2020 Periodic Inspection Report

*Lords Lake North Dam and East Dam
Jefferson County, Washington*

August 2020

DSO Files JE17-0243 & JE17-0357

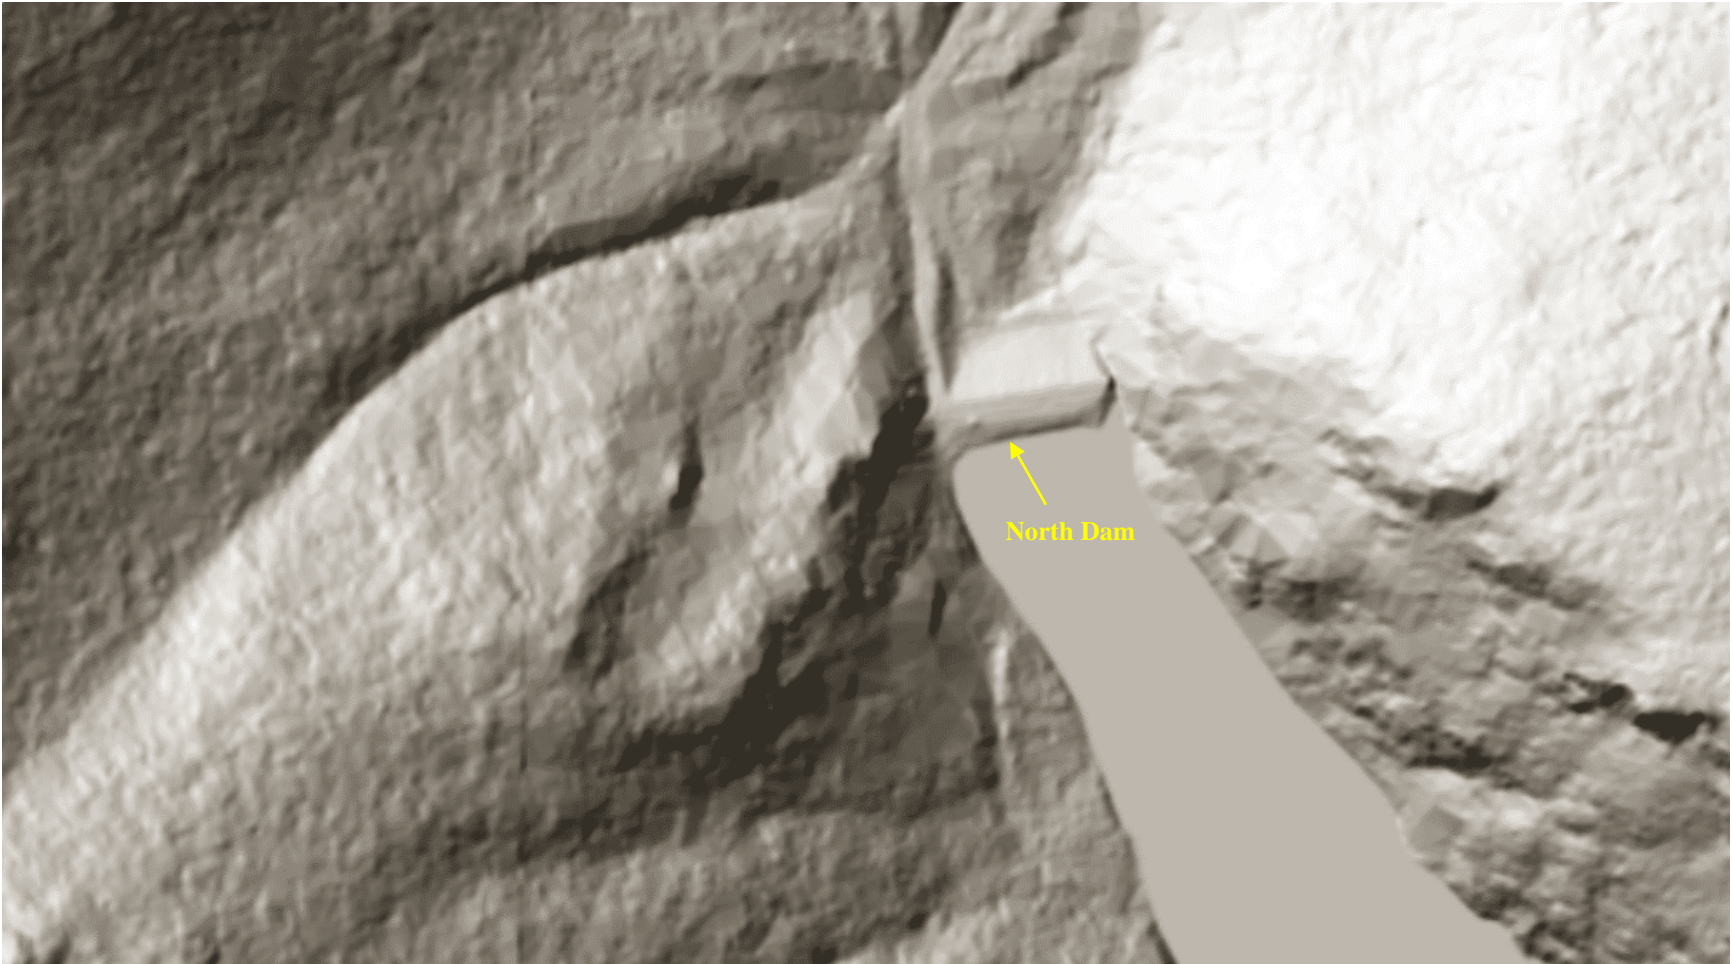
As seen on Figure 4, DNR coverage of the hillside along the eastern side of the dam does not show obvious signs of landslide activity. However, this section of the wall and hillside area above the channel should be periodically inspected and monitored to ensure there are no ground movements that may be adversely affecting the structural integrity of the wall.

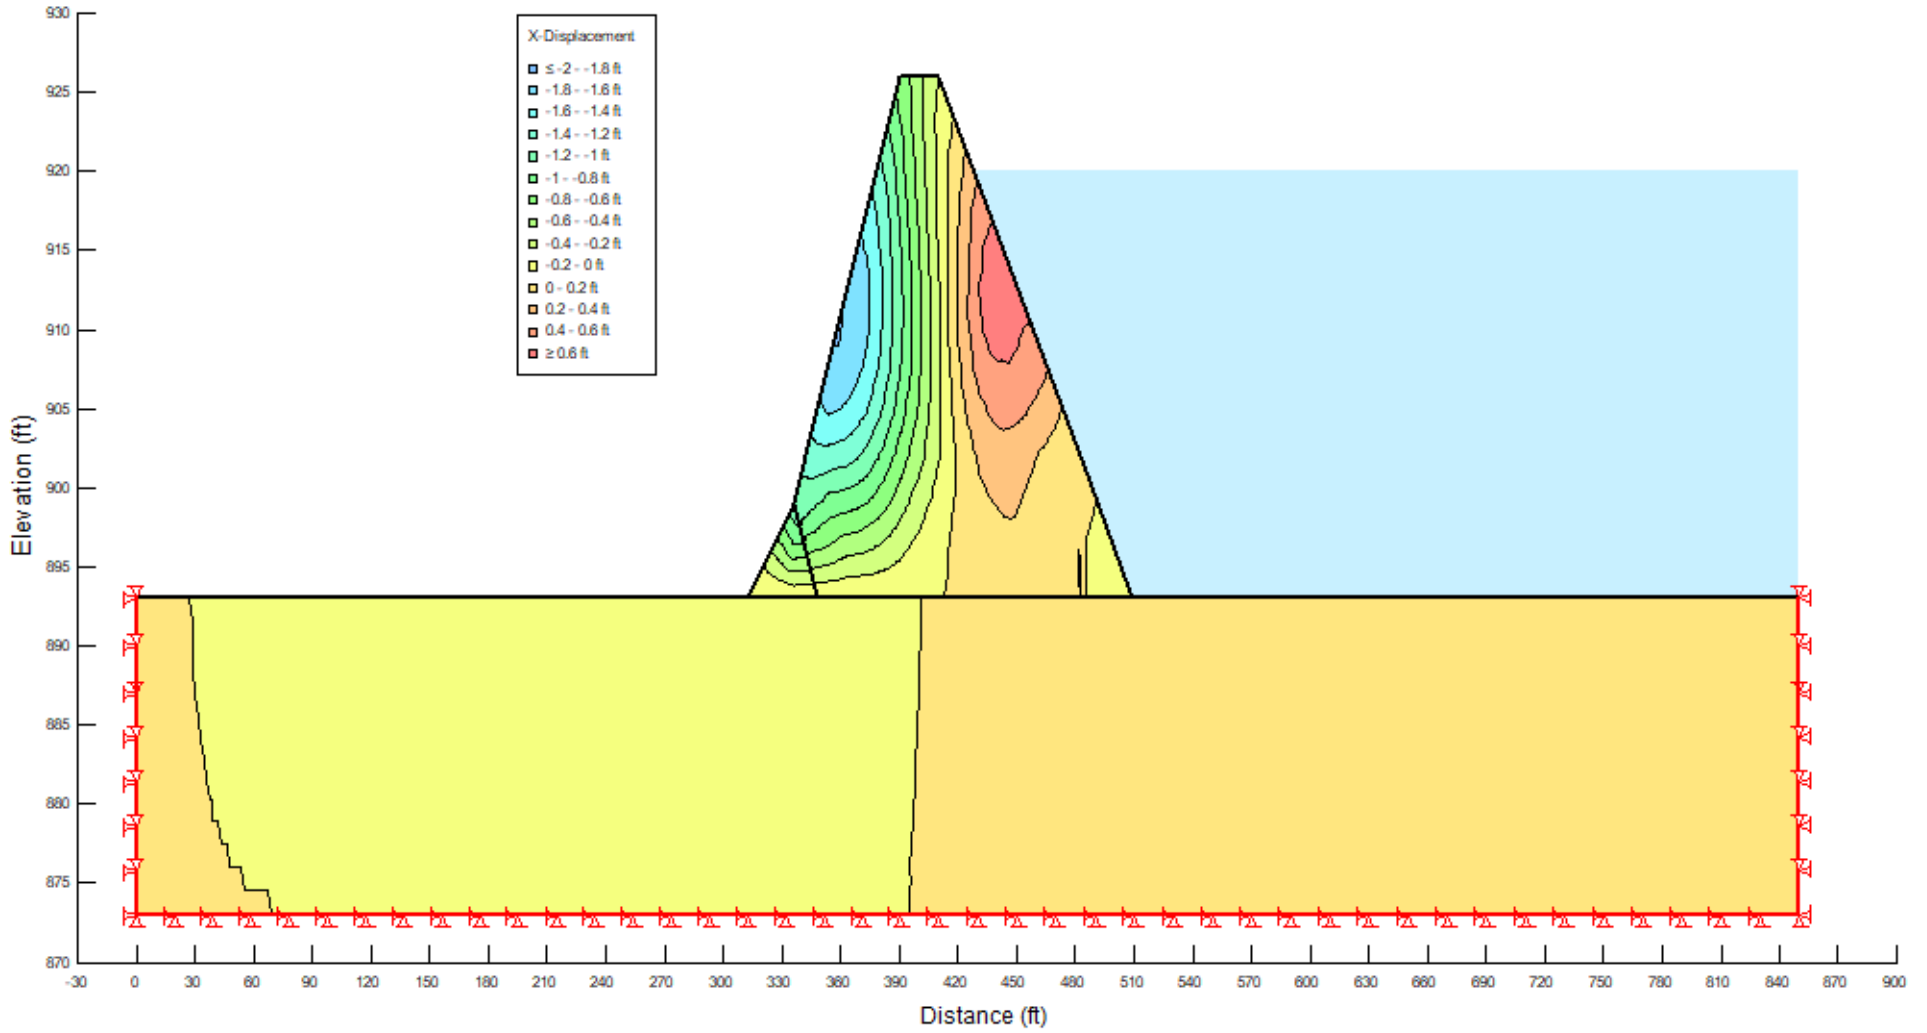
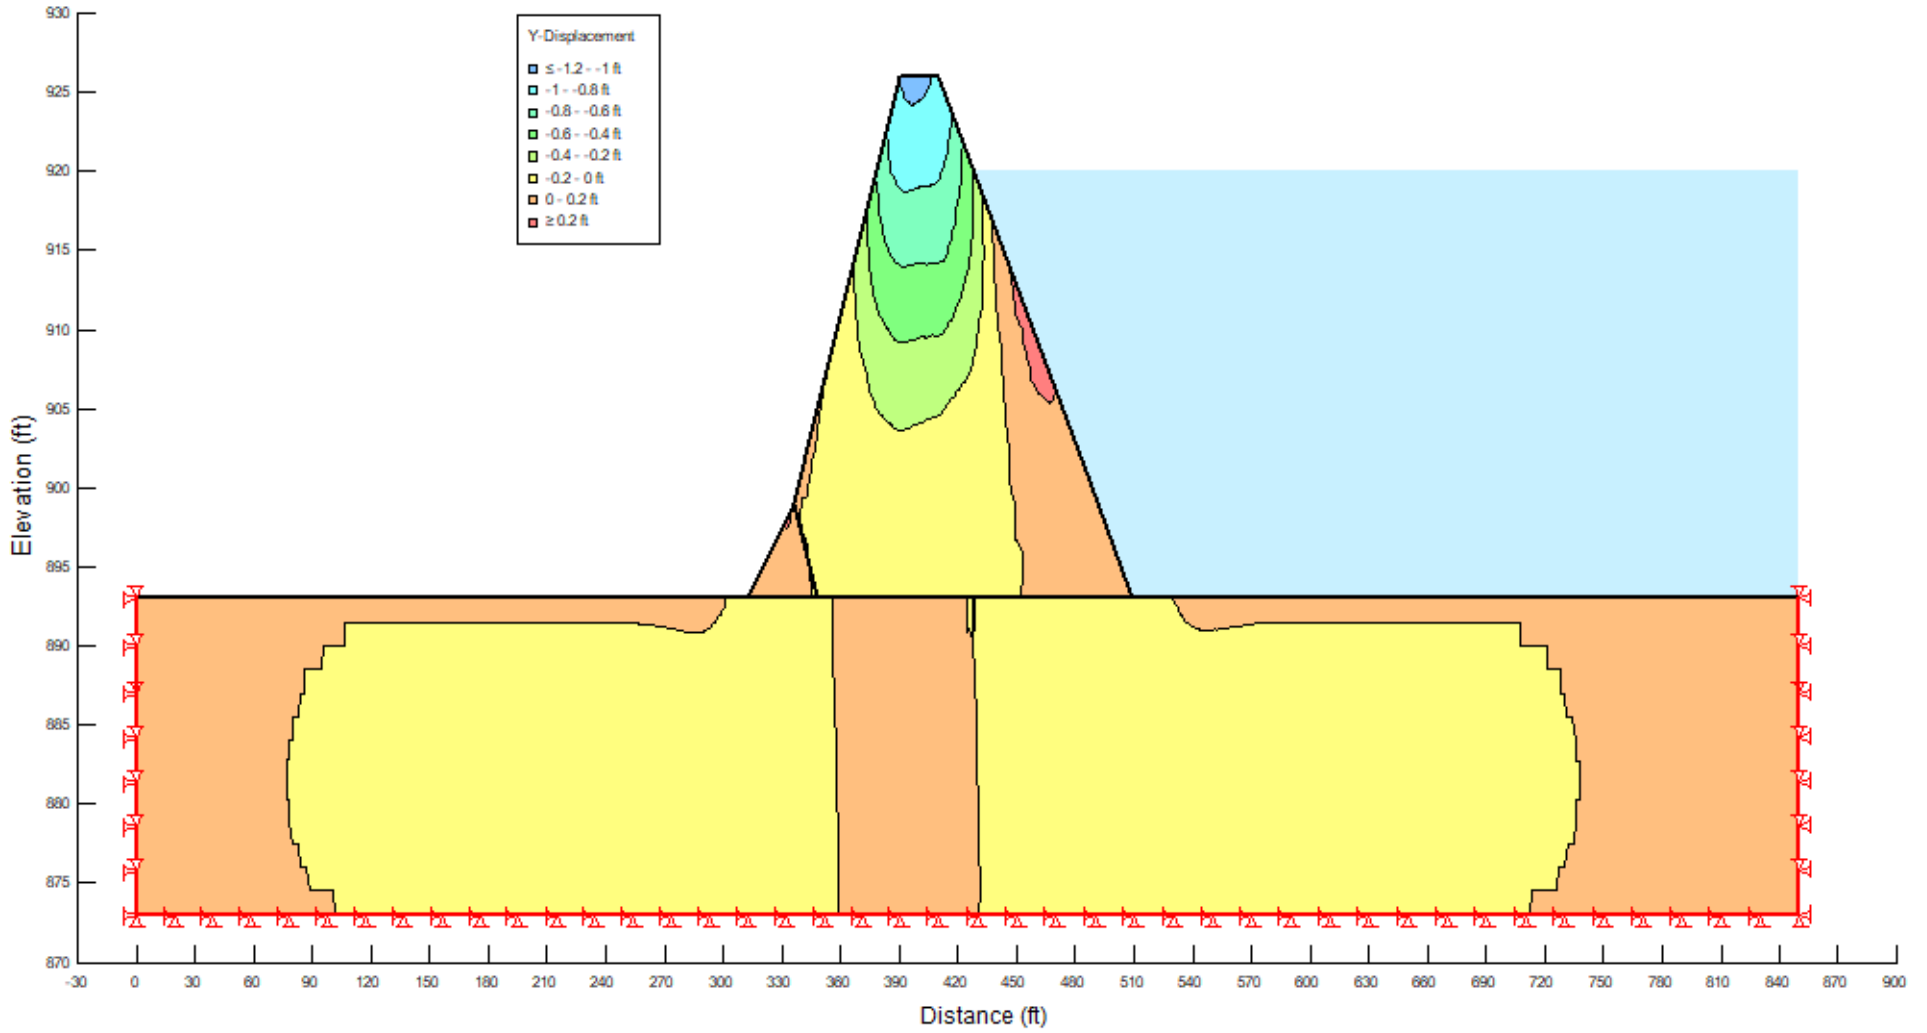
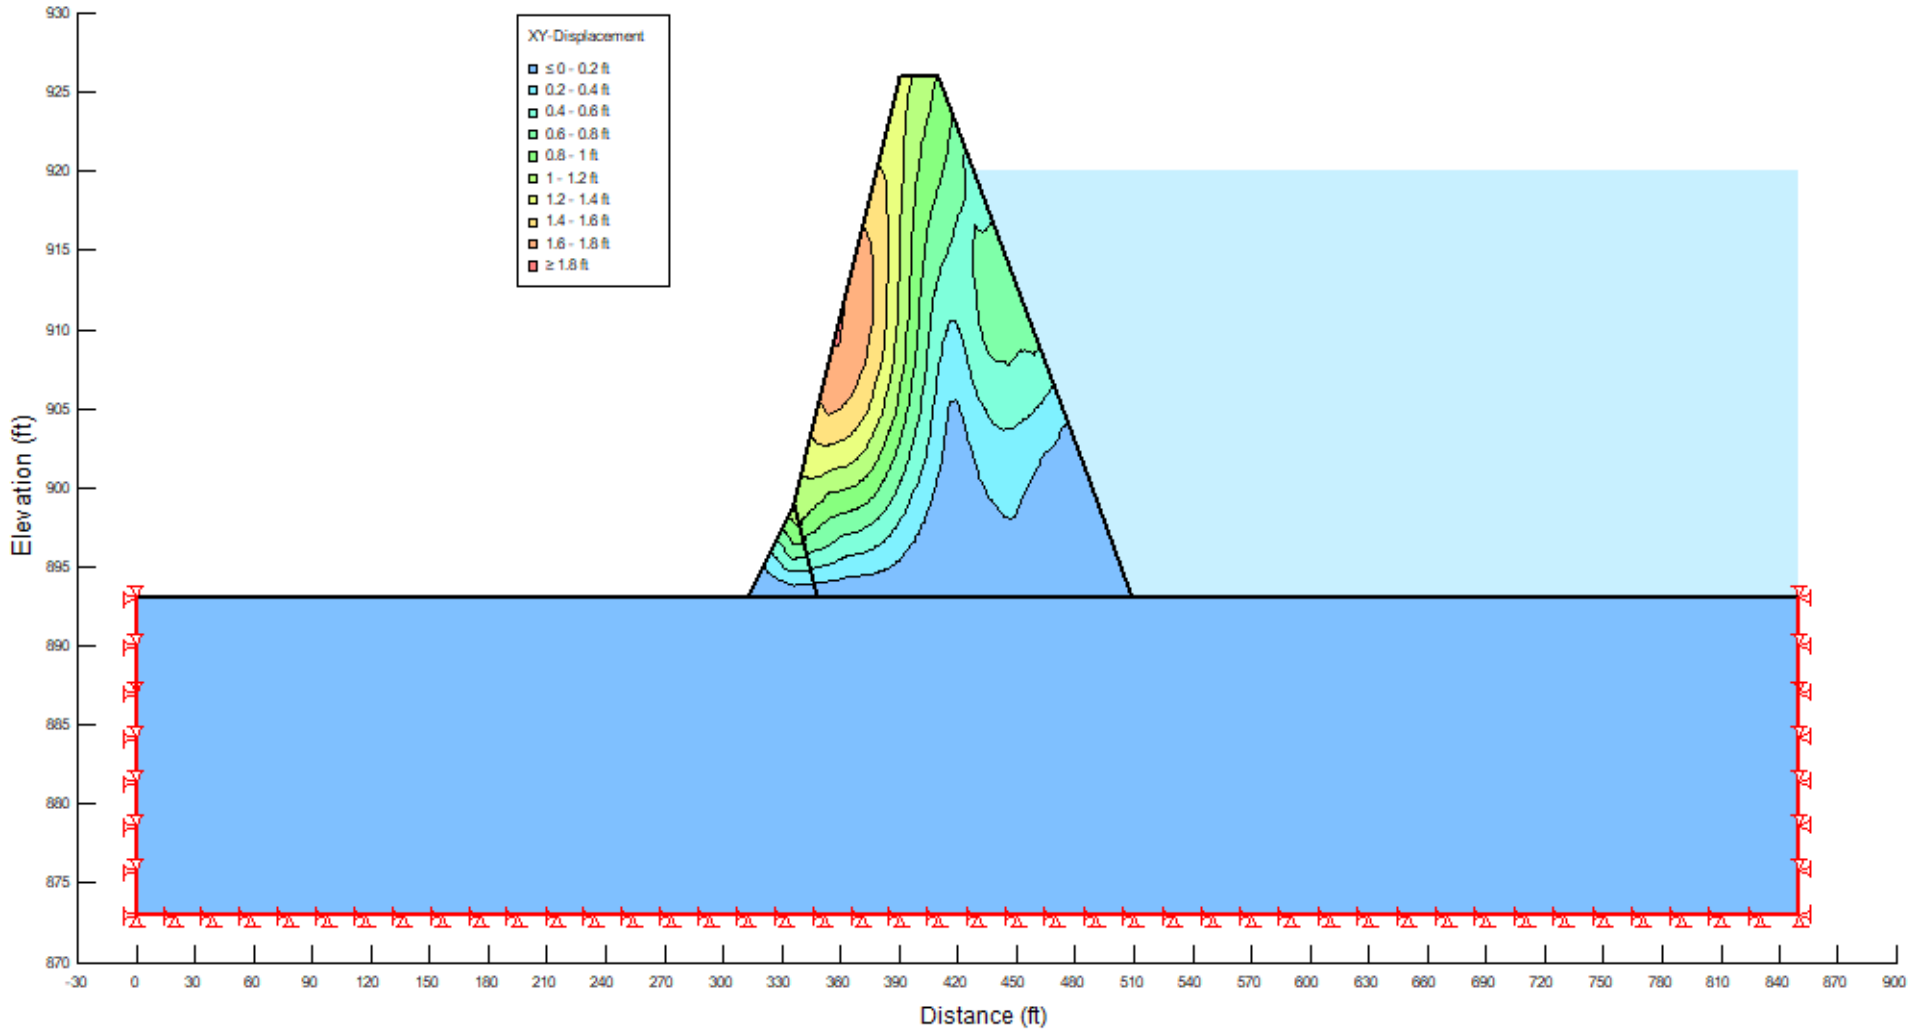
The results of the Sigma/W deformation analyses show downward vertical movements on the order of 0.4 to 1 foot from the top of the embankment and lateral translation on the order of 0.1 to 1-foot displacements at Section B-B'. An example of the results obtained for the Nisqually ENE component record are presented in Figures 12, 13, and 14. Since the deformations computed would only be a small fraction of the normal 6 feet of freeboard, failure of the dam by overtopping along section B-B' during the design earthquake appears to be acceptably unlikely.

To this end, it is necessary to better delineate the lateral extent of the loosely compacted embankment materials; to conduct additional dynamic analyses applying a more sophisticated model, e.g., nonlinear-effective stress, to better represent the behavior of the potentially liquefiable embankment materials and embankment response; and perhaps, to use a 3-D model to better evaluate the embankment response under seismic loading given the valley geometry.
